**ASHLAND PLANNING DIVISION
PRE-APPLICATION CONFERENCE
COMMENT SHEET** December 17, 2025

SITE: 510 Helman Street
APPLICANT: Nicholas Beall for Suncrest Homes
REQUEST: Physical & Environmental Constraints Review Permit for new Single-Family Dwelling Encroachment in the Ashland Modified Floodplain and Steep Slopes

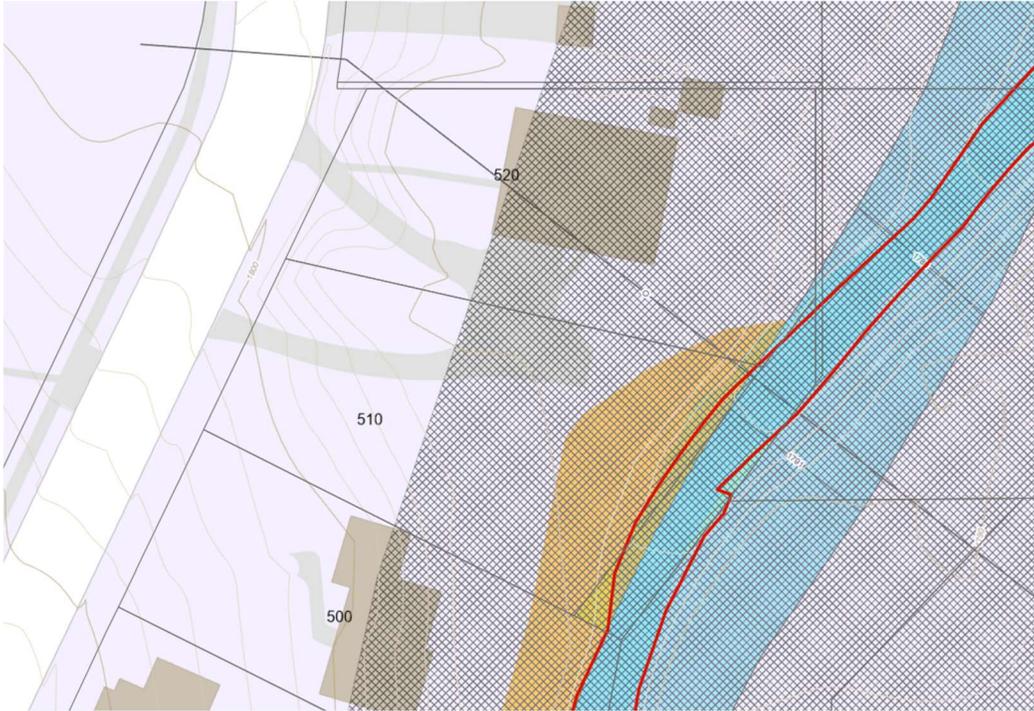
Summary: The proposal is for a new single-family dwelling to be constructed on the uphill portion of the lot, with some encroachment into the Ashland Modified Floodplain, but not into the 100-year floodplain, and some development into the steep slopes on the southern edge of the property. Due to the encroachment into the floodplain, a Flood Elevation Certificate (FEC) will be required at various stages of the project. The FEC would need to reflect both the requirements of AMC Chapter 15 (requiring 2' above BFE) and AMC Chapter 18 (requiring 1' above BFE) with 2' of additional freeboard (elevation above the BFE).

As stated in the July 8th, 2025 email from Aaron Anderson, CFM, Senior Planner with City of Ashland to the applicant, the FEMA BFE at section O appears to be 1791 and the Ashland Modified Floodplain elevation appears to be 1795 at the southern edge and 1790 at the northern edge of the lot. Due to this, the entire structure will need to be raised 2 feet above the highest elevation, making the structure elevated to 1797' or approximately 7 feet above the low elevation of the lot. Applicant should be aware that building to this standard may come with substantial expense to the applicant to be in compliance with floodplain regulations based on the current proposal and elevation data.

Note: An FEC prepared by a Professional Land Surveyor (PLS) or Professional Engineer (PE) will be required to confirm actual on the ground elevations for the structure's proposed location. There will need to be onsite inspections to verify finished floor elevations at foundation, framing, and final inspections.

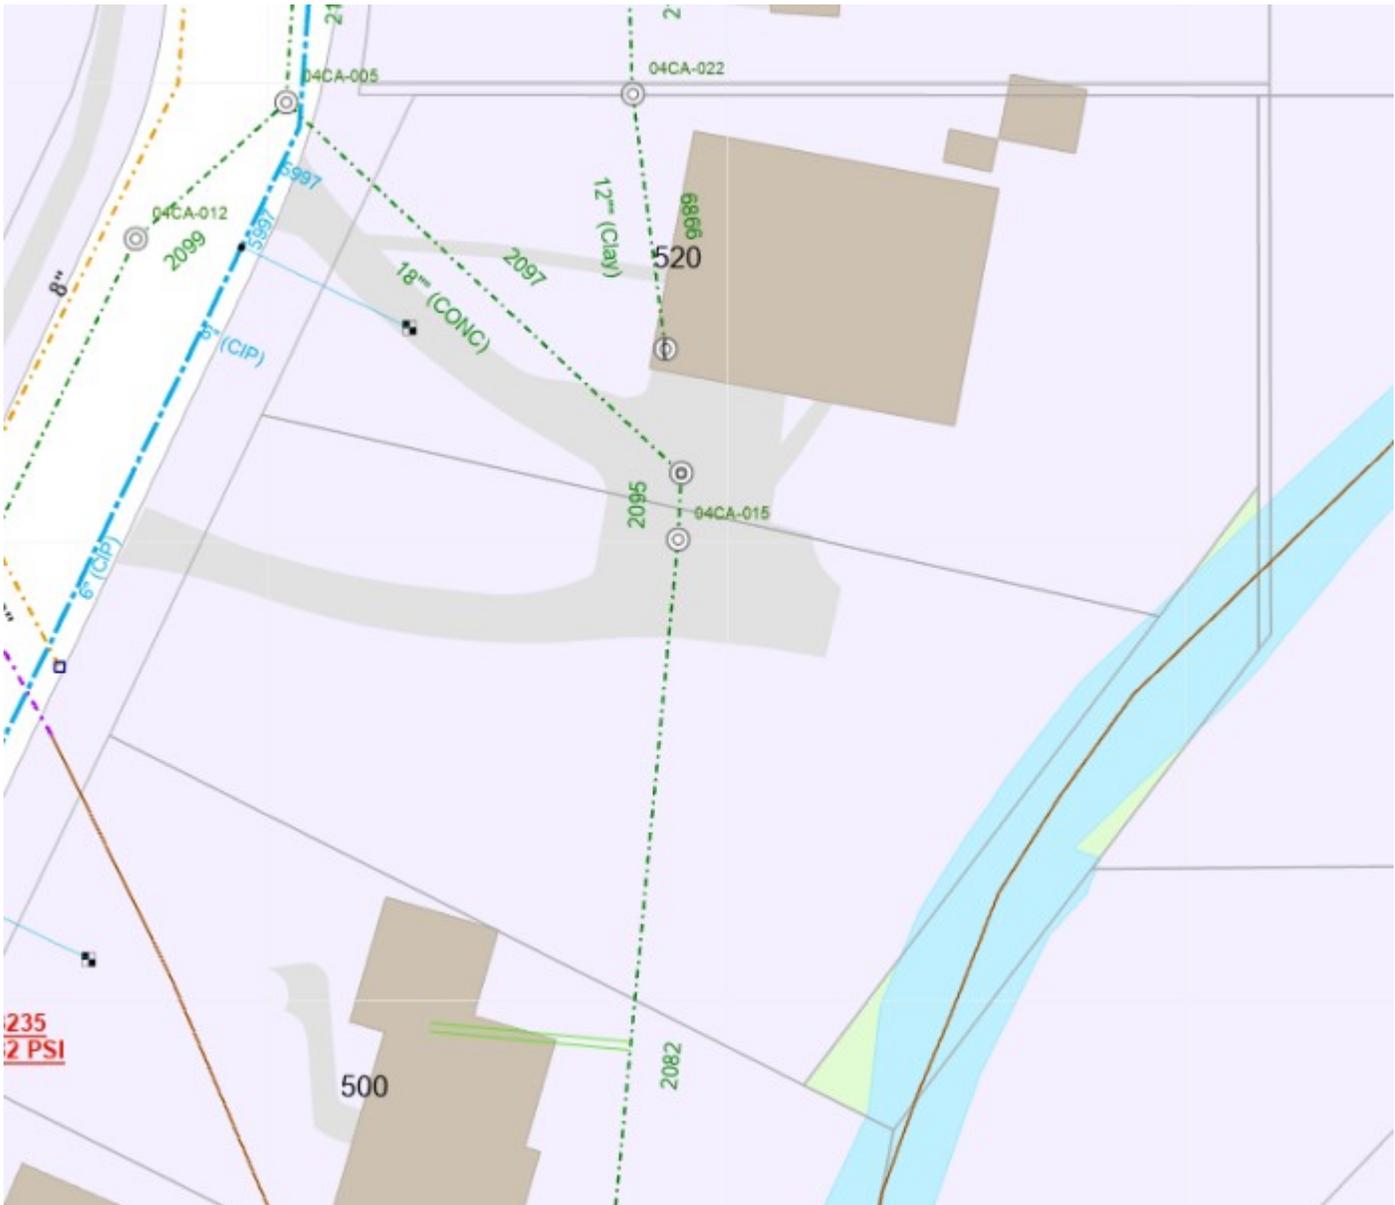
Below is a screen cap of a scan that I did of the locally adopted flood plain which includes the flood elevations. I have also attached a PDF with the relevant pages from the FEMA FIS, and the full scan.

The FEMA BFE appears to be 1791 at section O which runs through the existing house, 500 year elevation is 1792. The Ashland local flood elevation appears to be 1795 at the southern edge of the lot and 1790 just north of the northern lot, in between these we would need to interpolate.

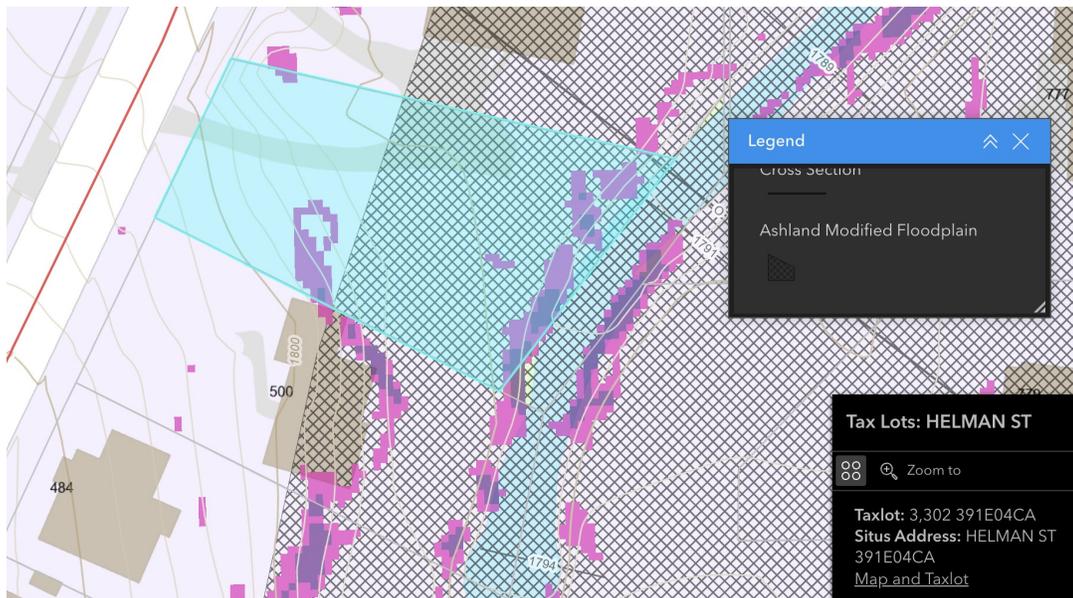
I have a question regarding a lot on Helman St (391E04CA 3302). I noticed that over 50% of the lot is within the Ashland Modified Floodplain, and I wanted to get your insights on potential restrictions associated with building in this area.

Specifically, I saw the code mentions that if more than 50% of the lot is within the floodplain,

construction may be allowed on the portion that is two feet or less below the flood elevations. Do you know where I can find the official flood elevation data for that lot?

I've attached a screenshot of the lot for your reference.

- I noticed that over 50% of the lot is within the Ashland Modified Floodplain, and I wanted to get your insights on potential restrictions associated with building in this area.

It is true that section F which provides for the hardship if more than 50% of the lot is in the flood zone, the previous section E is also still in effect "**To the maximum extent feasible, structures shall be placed on other than Flood Plain Corridor Lands.**" It appears that there is at least 75 feet of land that is outside of the modified flood zone, and we would encourage any new development to occur in that area. [Additionally there is a 50' riparian buffer from the bank per the WRPZ [AMC 18.3.11]

That said, IF someone were to propose a project that encroached into the flood plain construction to finished floor elevation would need to be +2 over BFE (chapter 18 only requires 1 foot, but chapter 15 where the NFIP regulations reside requires two-feet of freeboard). A planning action would be required and flood elevation certificates would be required at several stages in construction.
